ARC REVIEW CODE: R1709252

**Name of Proposal:** 740 West Peachtree (DRI 2707)

**Review Type:** Development of Regional Impact

**740 WEST PEACHTREE DRI**  
**City of Atlanta**  
**Natural Resources Review Comments**  
**September 21, 2017**

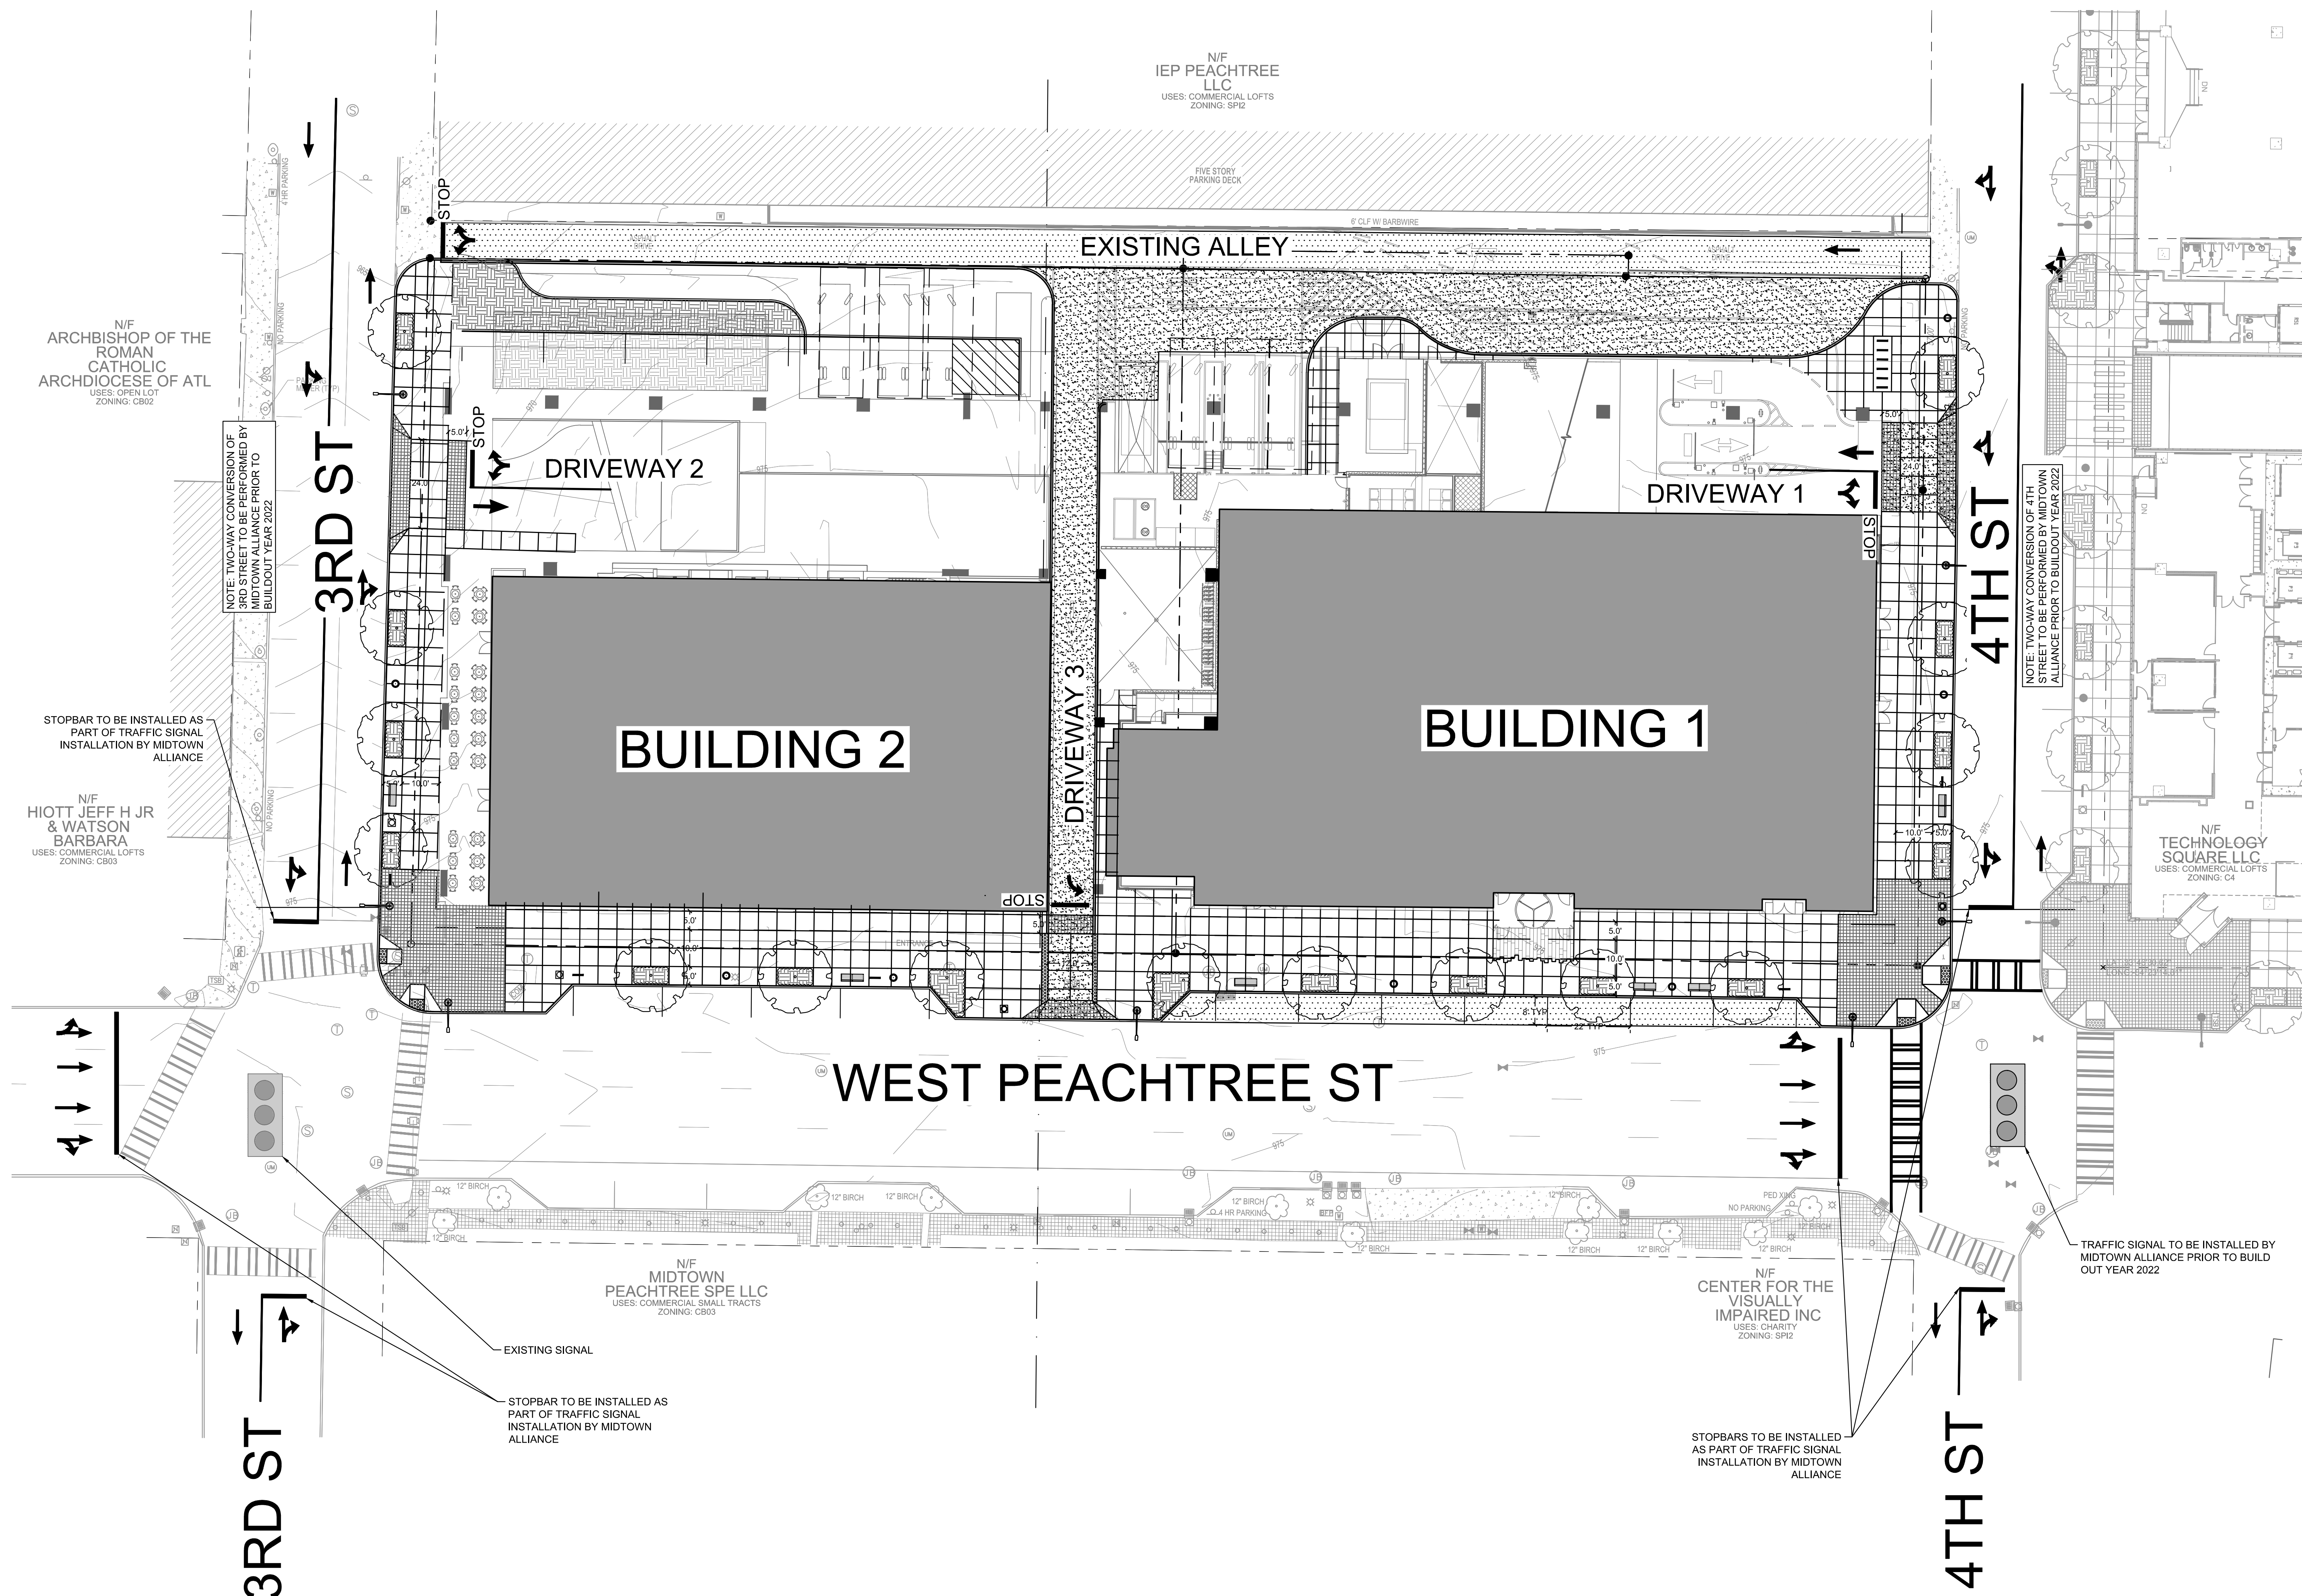
The project is bounded by public roadways on all sides with existing development surrounding the site. The site plan does not depict adjacent parcels or their driveways to determine if inter-parcel connectivity is planned or possible, nor is it mentioned in the traffic analysis.

The site plan does depict some internal sidewalks however bicycle facilities are not depicted.

The site is bounded by public roadway on all sides with public sidewalk connectivity already existing. Adjacent parcels are developed. The site plan does not indicate bicycle access or connectivity to adjacent parcels being added.
